**NOTICE OF ADDENDUM**  
**ADDENDUM NO. 2**  
**CONTRACT NO. 6994**

**LIVINGSTON STREET RESURFACING WITH UTILITIES**  
**ASSESSMENT DISTRICT – 2013**

LIVINGSTON ST RESURFACING W/ UTILITIES	SHEET NO.
PROJECT NO. 53W1462	U-4
UTILITIES	
STORM SEWER SCHEDULE	CITY OF MADISON

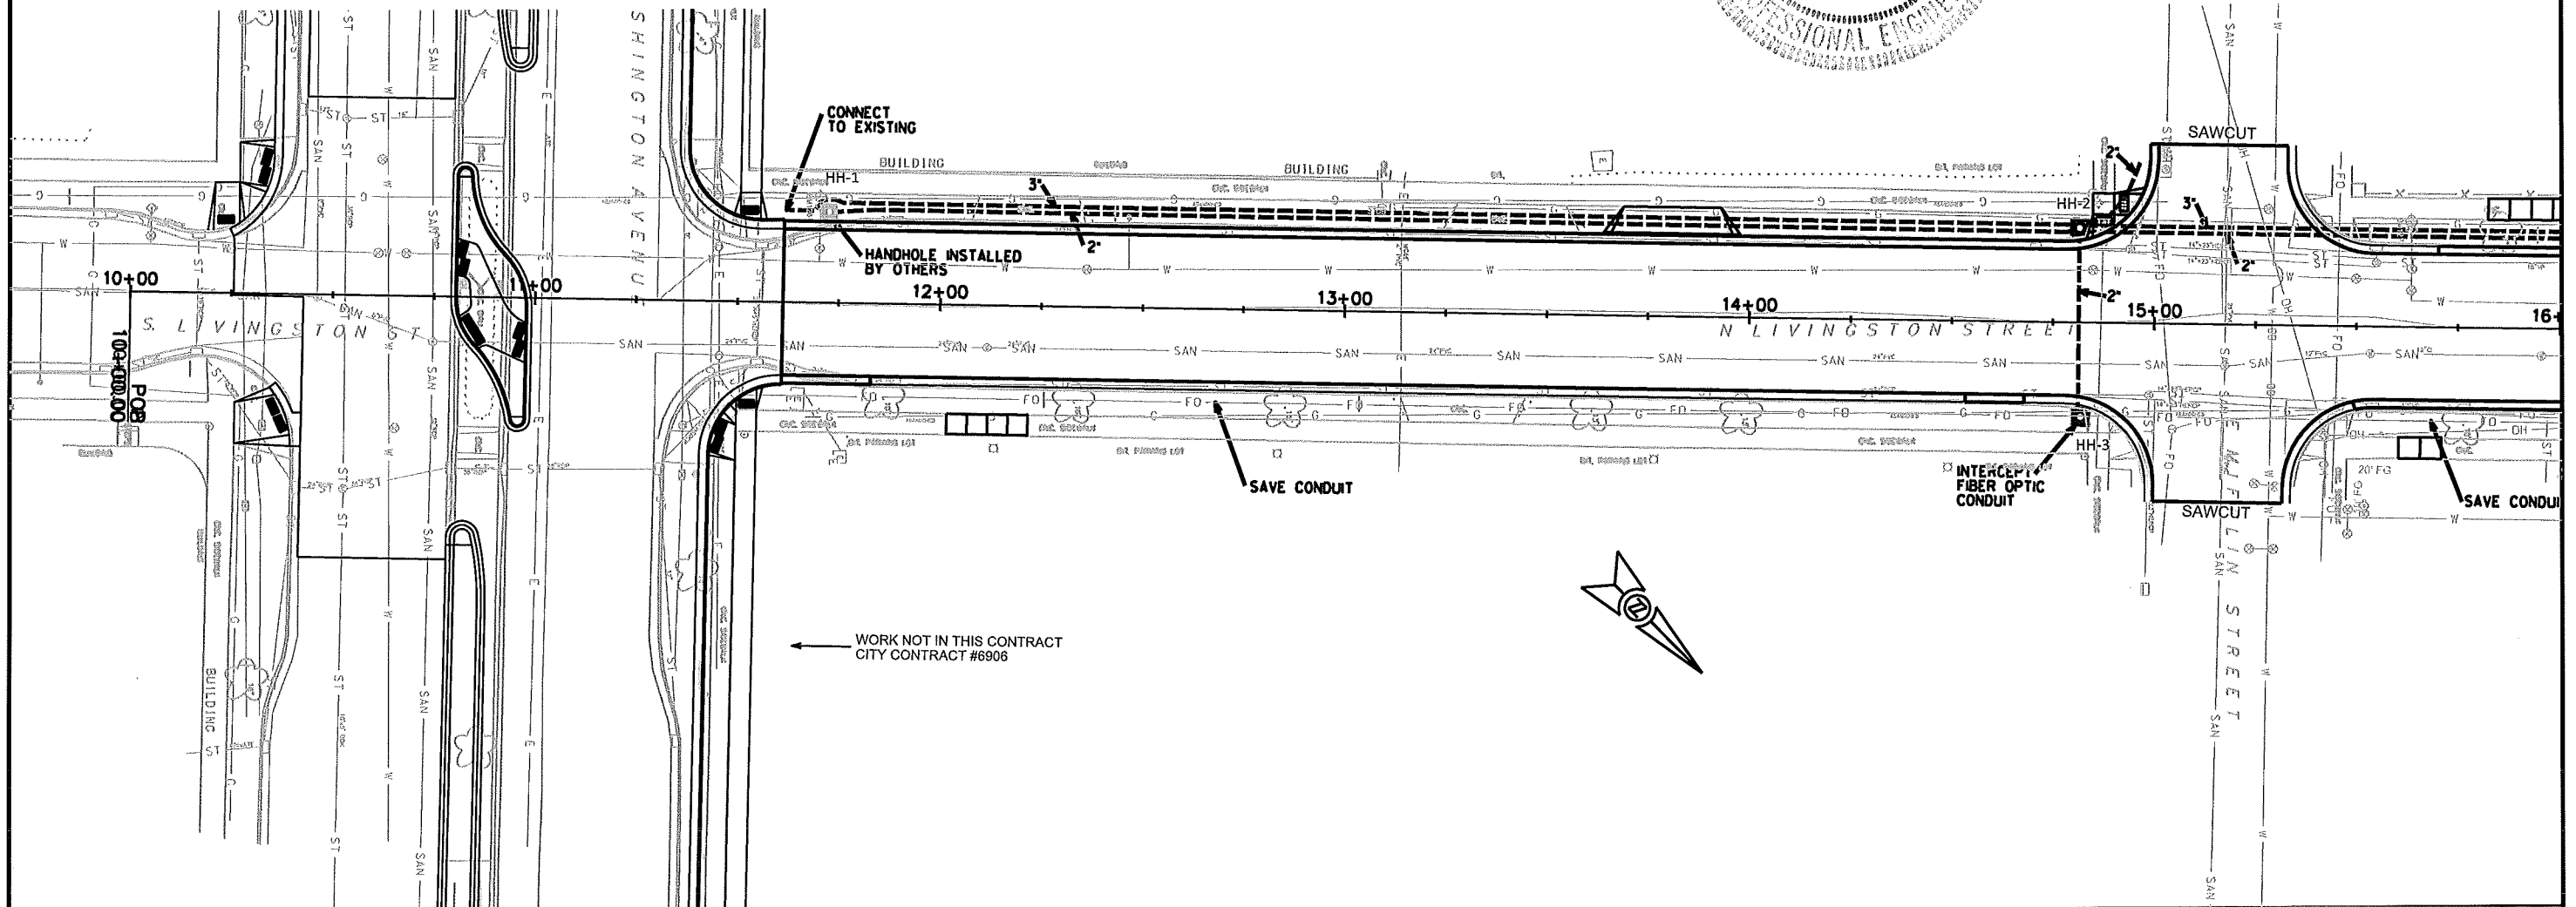
- Revised electrical plans and item quantities.
- Revised U-4 Storm Sewer Schedule and storm structure quantities, specifically revising bid item 50725 quantity and adding bid item 50726 – 6'x6' STORM SAS.
- Revised description of bid item 90030 – STORM CONTROL AND IMPLEMENTATION PLAN. Revised key existing storm sewer connections.
